Item Name: Quick Release Heli-Utility-Basket™ Long, HD Lid, Spacepod™/Squirrel Check Comp.

DART SERVICE INSTRUCTION

TO AMEND INSTALLATION INSTRUCTIONS D350-607-3 Rev.D,
INSTALLATION INSTRUCTIONS D350-607-4 Rev. C AND
INSTRUCTIONS FOR CONTINUED AIRWORTHINESS ICA-D350-607 REV. 6

A	NEW ISSUE	AJS	14.05.16
REV.	DESCRIPTION	BY	DATE
DESIGN	AJS	DART AEROSPACE LTD	
DRAWN	AJS	HAWKESBURY, ONTARIO, CANADA	
CHECKED		DRAWING NO.	REV. A
MFG. APPR.	N/A	DSI 9699	SHEET 1 OF 2
APPROVED		TITLE	SCALE
DE APPR.		LUG REPLACEMENT	NTS
DATE	14.05.16	COPYRIGHT © 2014 BY DART AEROSPACE LTD	
THIS DOCUMENT IS PRIVATE AND CONFIDENTIAL AND IS SUPPLIED ON THE EXPRESS CONDITION THAT IT IS NOT TO BE USED FOR ANY PURPOSE OR COPIED OR COMMUNICATED TO ANY OTHER PERSON WITHOUT WRITTEN PERMISSION FROM DART AEROSPACE LTD.

FIGURE 1: INSTALLATION OF D4775-041 FWD STRUT

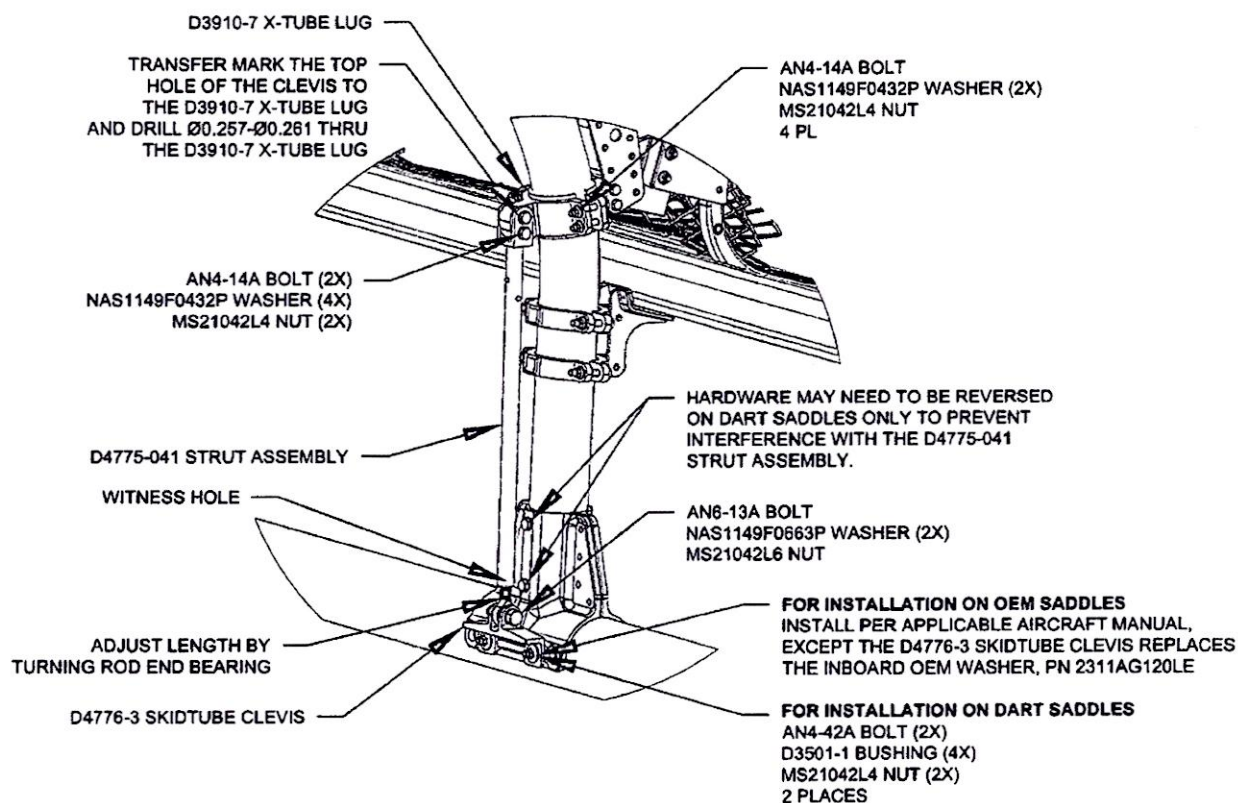
3.1 Substitute the Forward Lower D3910-5 X-Tube Lug with the D3910-7 X-Tube Lug as shown in Figure 1.

3.2 Install the forward D4775-041 Strut Assembly. Transfer mark from the upper hole on the clevis of the D4775-041 Strut Assembly to the D3910-7 X-tube Lug and drill thru the lug $\varnothing 0.257$ - $\varnothing 0.261$ as shown in Figure 1. Touch up chemical conversion coating per MIL-DTL-5541. Check the witness holes located at the bottom end of the D4775-041 Strut Assemblies to ensure that the thread from the rod end extends past the witness hole.
Torque MS21042L4/-4 nuts to 50-70 in-lbs (5.7-7.9 N-m). Torque MS21042L6/-6 nuts to 160-190 in-lbs (18.1-21.5 N-m).
